# UNITED STATES PATENT AND TRADEMARK OFFICE

APPLICATION NO.	FILING DATE	FIRST NAMED INVENTOR	ATTORNEY DOCKET NO.	CONFIRMATION NO.
10/584,937	10/12/2006	Joon-Young Ahn	3329-114	1149

<b>Office Action Summary</b>	<b>Application No.</b> 10/584,937	<b>Applicant(s)</b> AHN, JOON-YOUNG	
	<b>Examiner</b> KAREEN RUSH	<b>Art Unit</b> 3781

## **DETAILED ACTION**

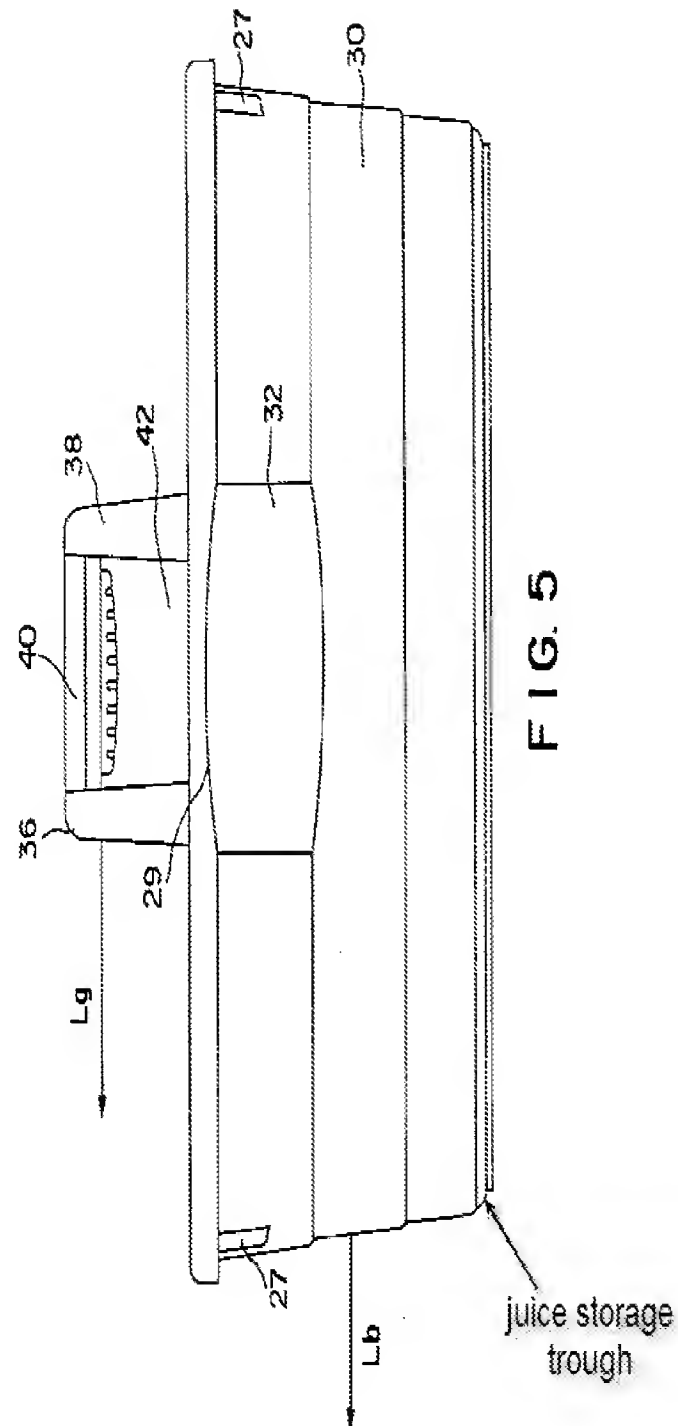
a. Regarding claim 1, Flink teaches a container (Fig. 6) for a vacuum packing, comprising of a base panel (in the below annotated Fig. 6) to be put into a vacuum bag (the container can be put into a vacuum bag), with an item to be packed being laid on the base panel (items are intended to be laid on the base) and a front panel (in the below annotated Fig. 6) provided at a front position of the base panel with an air hole (Fig. 6 at 25) formed on the front panel.

b. Regarding claim 2, Flink teaches an embossment (Fig. 6 at 24) is provided on the base panel to define an air discharge path.

c. Regarding claim 5, Flink teaches a first guide panel (in the below annotated Fig. 6) extends outward from a position above the air hole to a predetermined position, and a second guide panel (in the below annotated Fig. 6) extends outward from a position under the air hole to a predetermined position.

- d. Regarding claim 6, Flint teaches a juice storage trough is provided at a position around the base panel (in the below annotated Fig. 6 and 5; the base of Fig. 5 is the base used in Fig. 6)

- e. Regarding claim 8, Flink teaches a first guide panel (in the below annotated Fig. 6) extends outward from a position above the air hole to a predetermined position, and a second guide panel (in the below annotated Fig. 6) extends outward from a position under the air hole to a predetermined position.

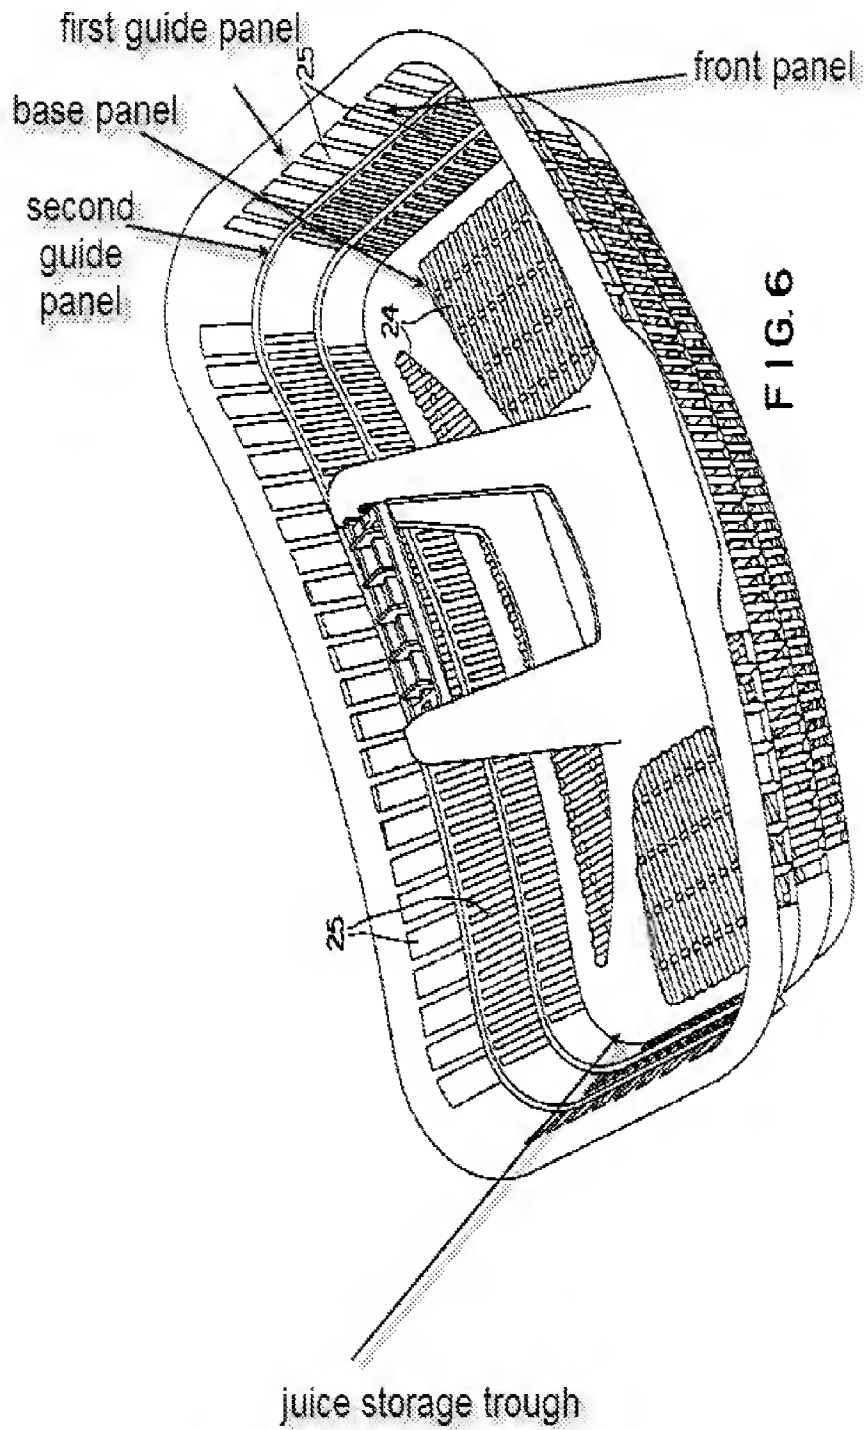
- h. Regarding claim 1, Meehan teaches a container (Fig. 1) for a vacuum packing, comprising of a base panel (Fig. 1 at 13 and 14) to be put into a vacuum bag (the container can be put into a vacuum bag), with an item to be packed

being laid on the base panel (items are to be laid on the base) and a front panel (Fig. 1 at 18) provided at a front position of the base panel with an air hole (Fig. 1 at 27) formed on the front panel.

- i. Regarding claim 2, Meehan teaches an embossment (in the below annotated Fig. 1) is provided on the base panel to define an air discharge path.
- j. Regarding claim 4, Meehan teaches the base panel is adjustable in length (as can be seen in Fig. 5 with the removal of member 50).
- k. Regarding claim 7, Meehan teaches the base panel is adjustable in length (as can be seen in Fig. 5 with the removal of member 50).

**FIG. 8**

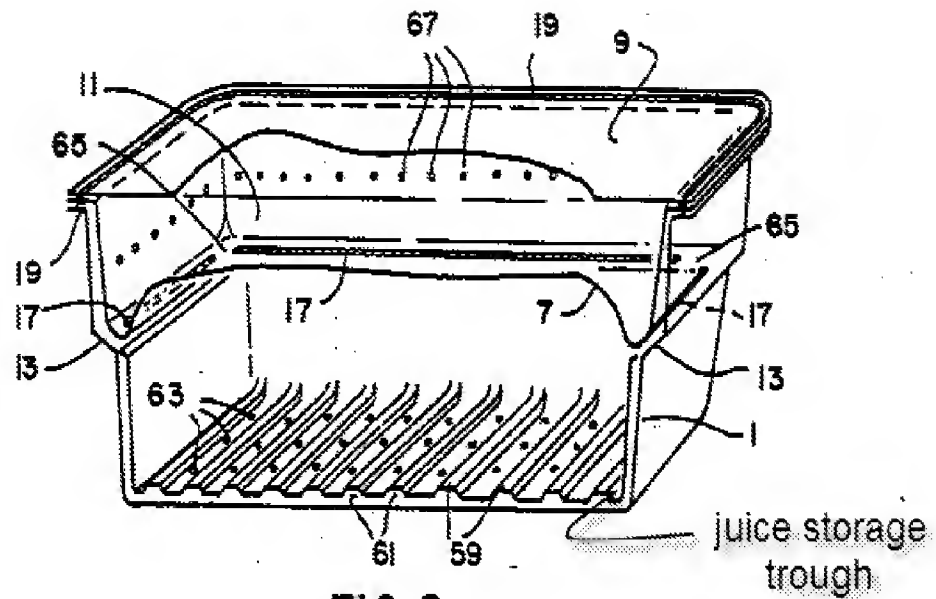
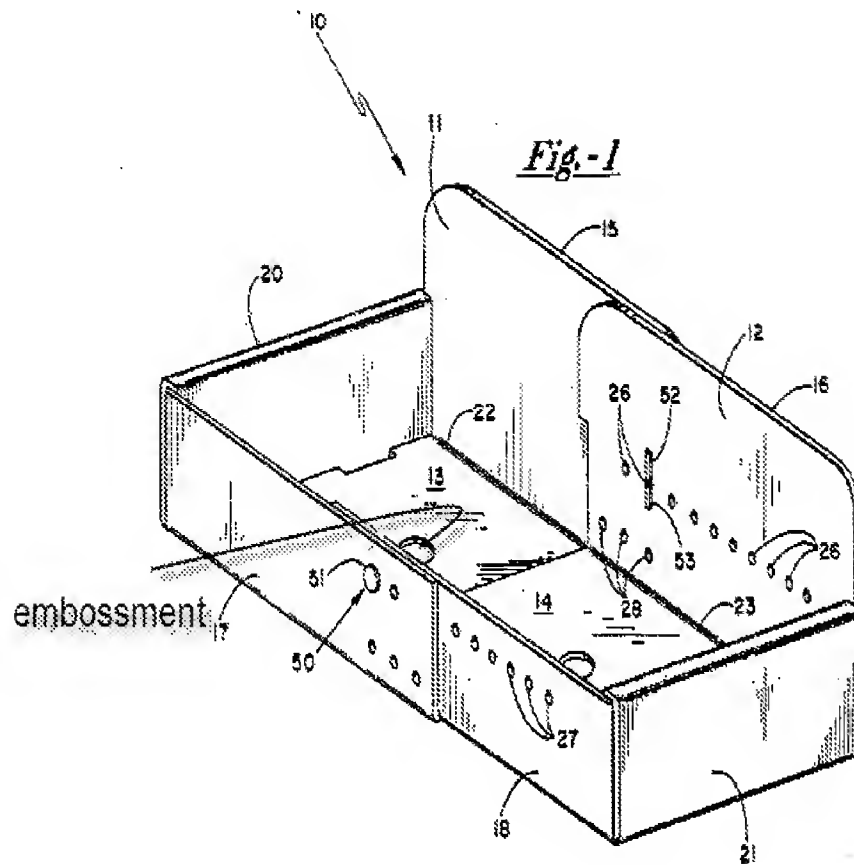
3. Claims 1 and 3 are rejected under 35 U.S.C. 102(b) as being anticipated by Garwood (5155974).
- f. Regarding claim 1, Garwood teaches a container (Fig. 8) for a vacuum packing, comprising of a base panel (Fig. 8 at 59) to be put into a vacuum bag (the container can be put into a vacuum bag), with an item to be packed being laid on the base panel (food products are to be laid on the base) and a front panel (Fig. 8 at 9) provided at a front position of the base panel with an air hole (Fig. 9 at 67) formed on the front panel.

- g. Regarding claim 3, Garwood teaches a juice storage trough (in the below annotated Fig. 8) is provided at a position around the base panel.
4. Claims 1, 2, 4 and 7 are rejected under 35 U.S.C. 102(b) as being anticipated by Meehan (5192019).
